Title: Sequencer-Logic-Prod-V2.1-copy sheet 5

Title: Sequencer-Logic-Prod-V2.1-copy sheet 6

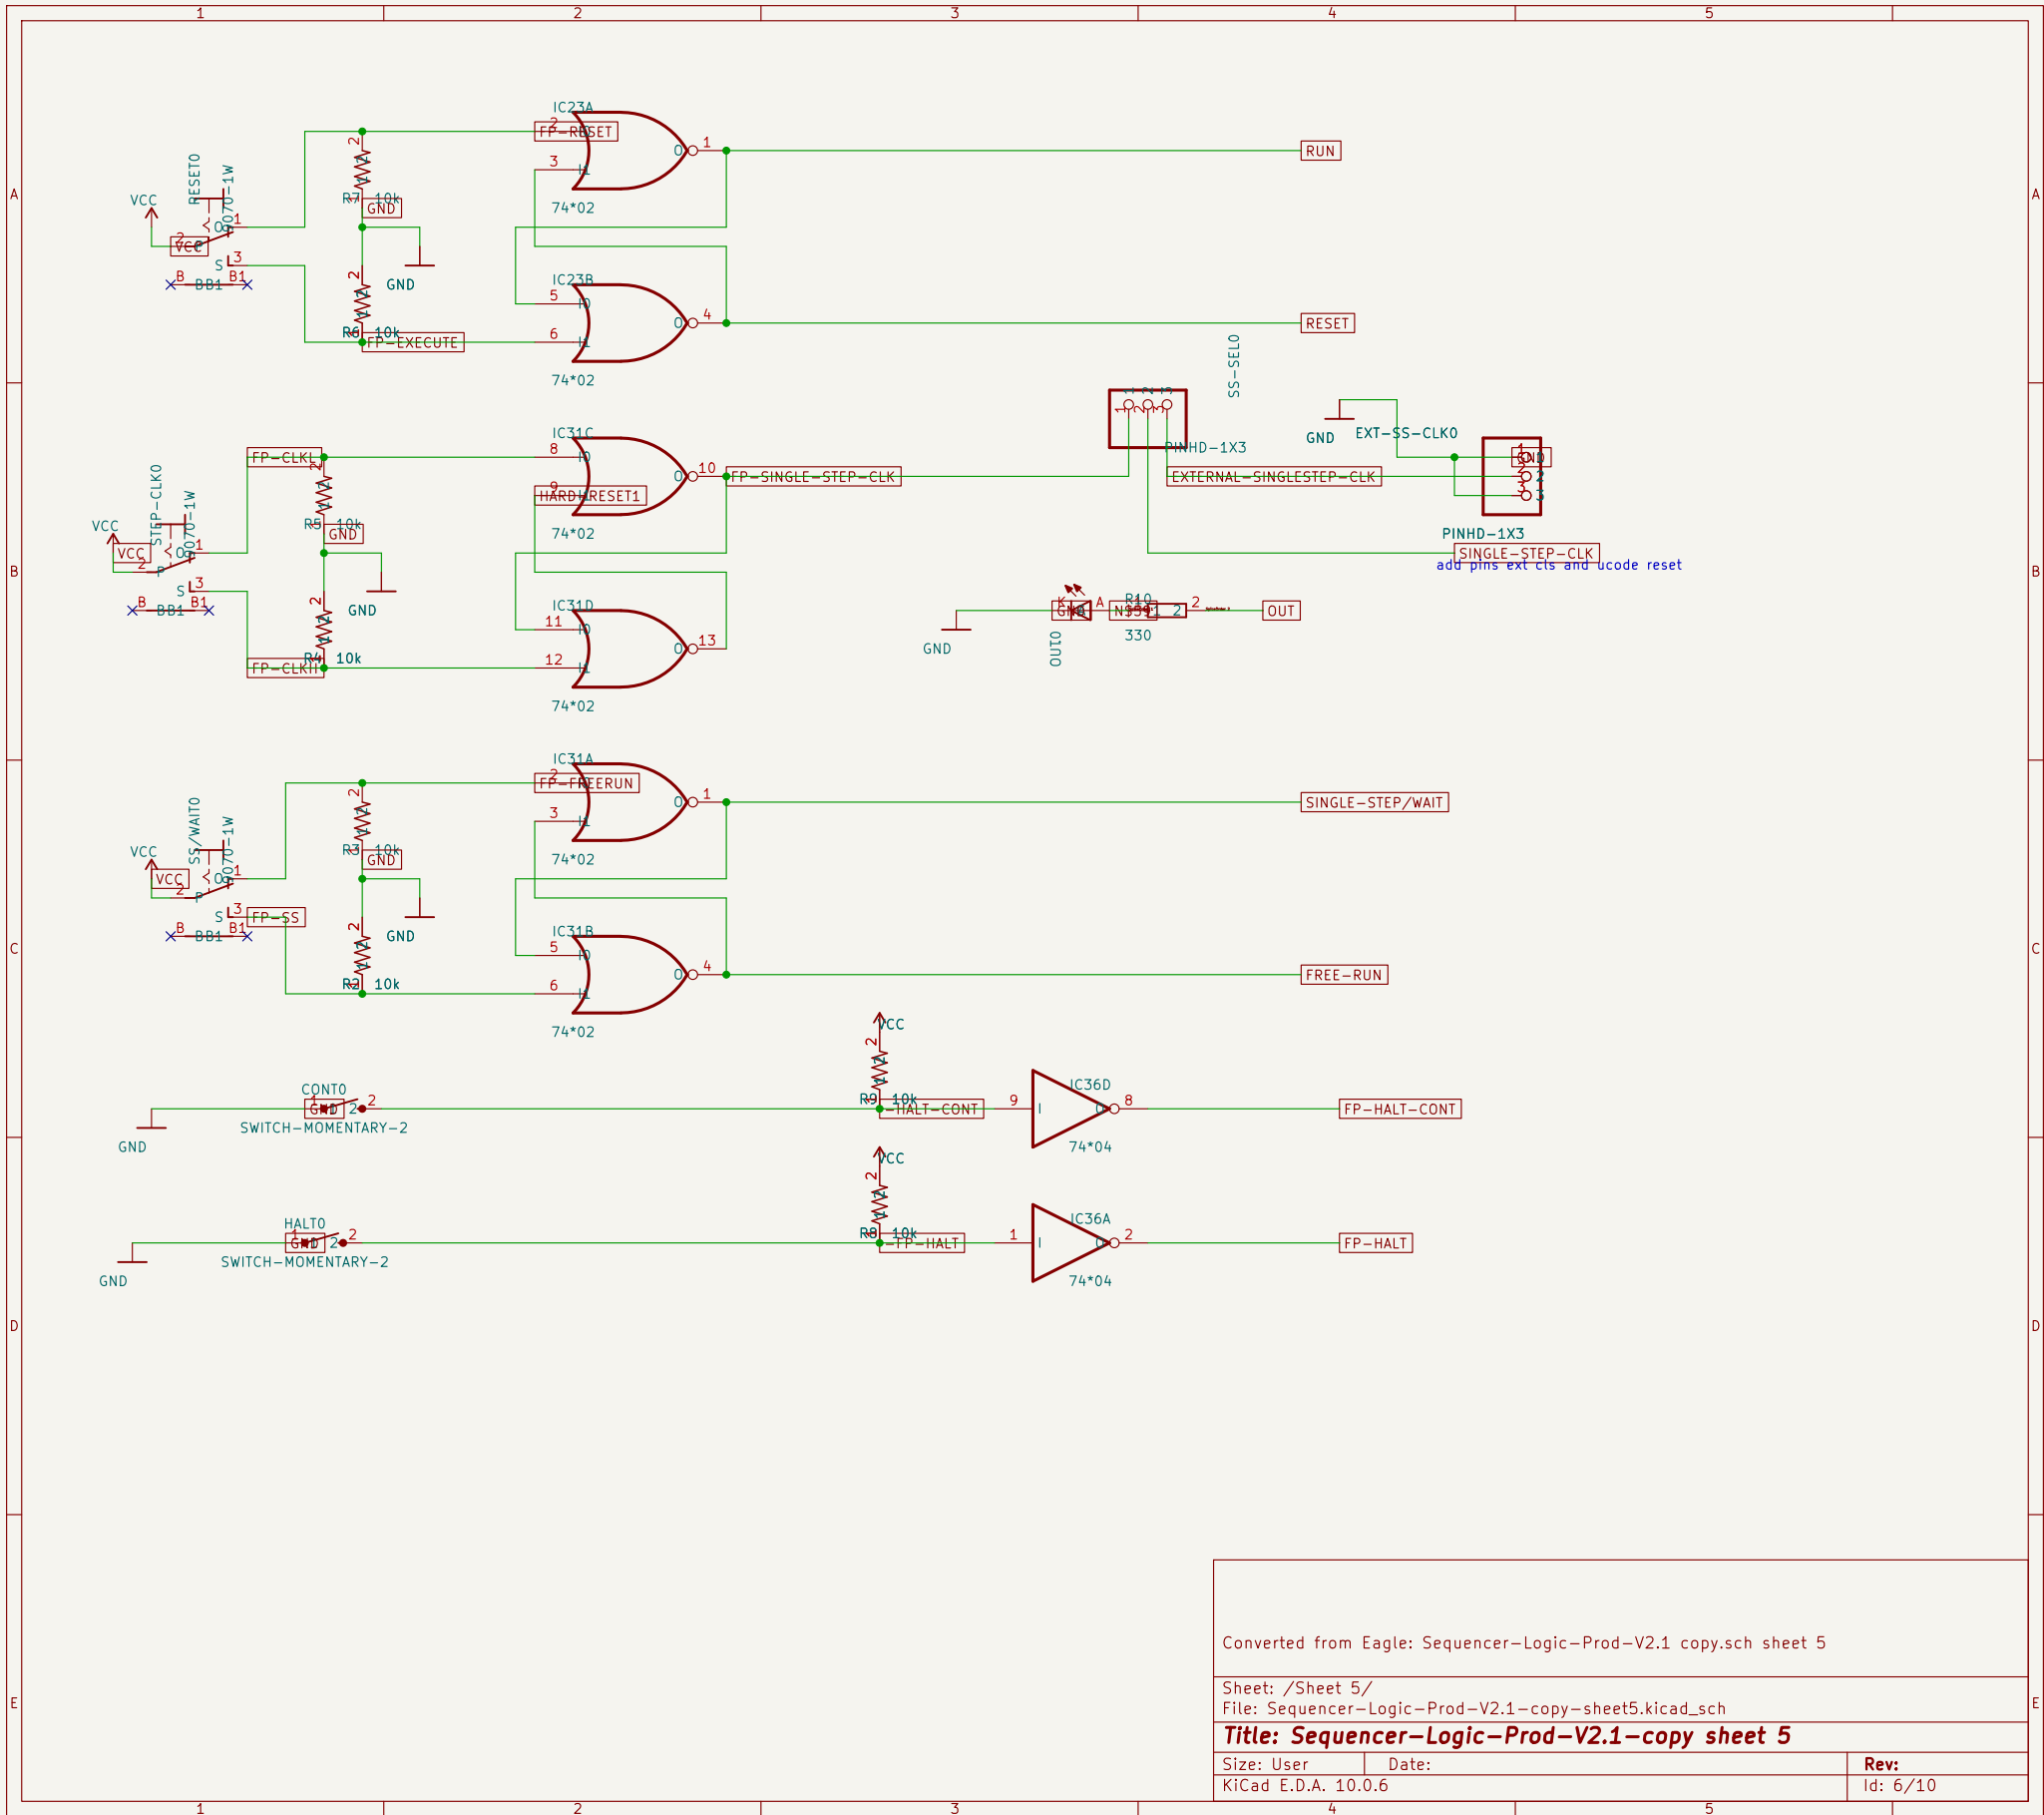
Should operand clk be part of mem-logic or generated signal

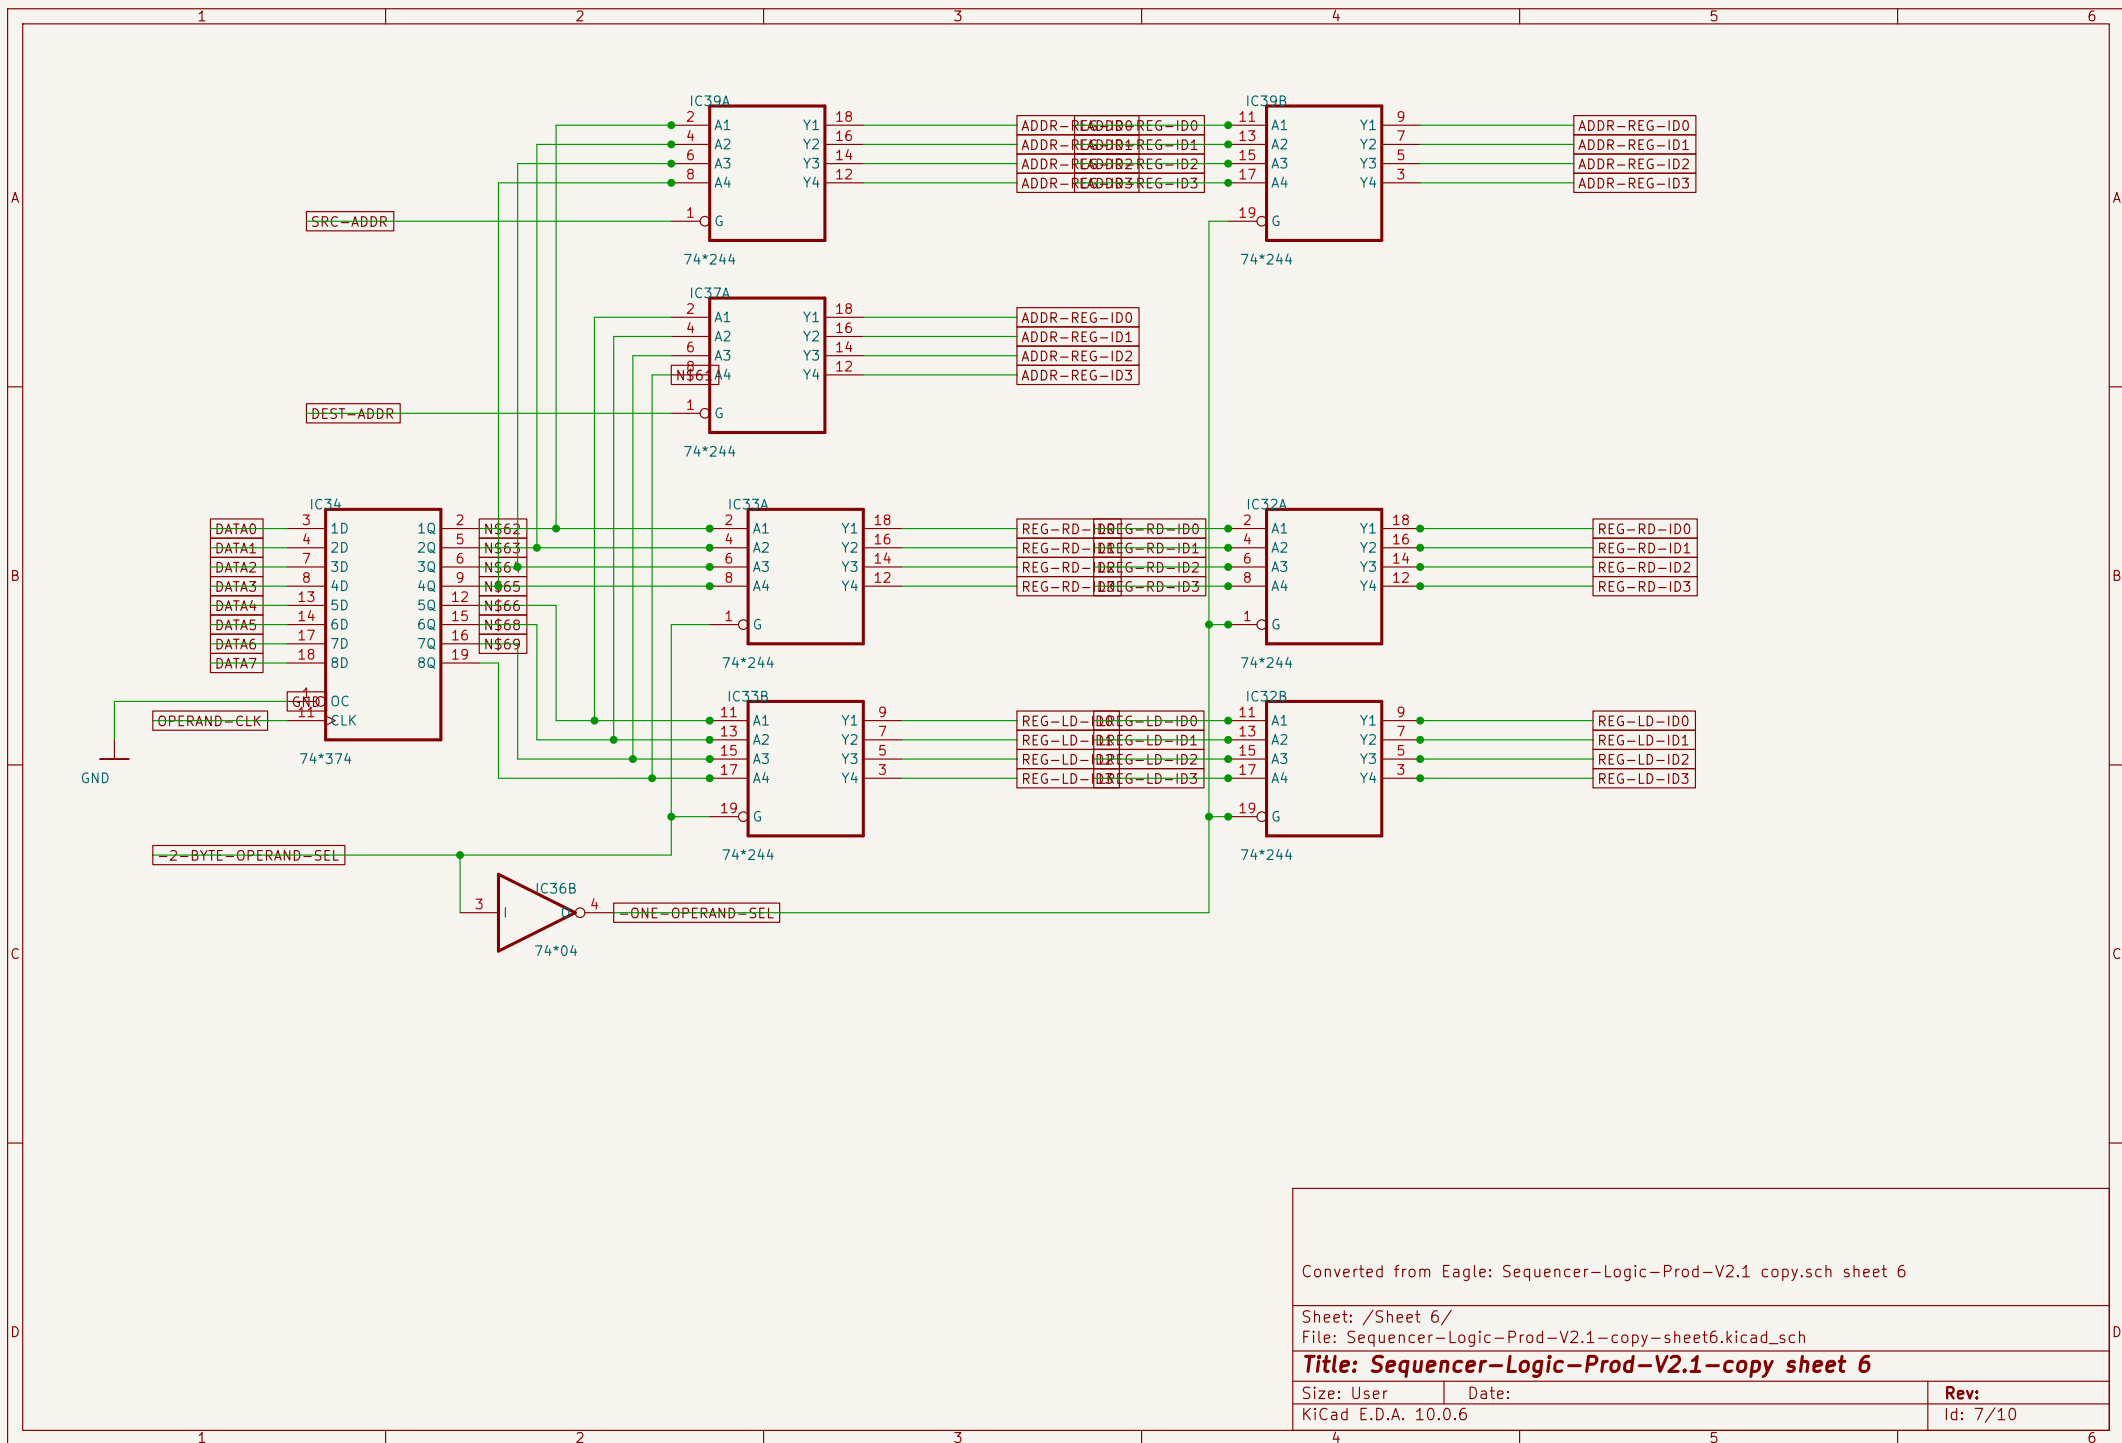
drive reg-rd/ld and ioaddr from separte signals and add to drive addr line driving
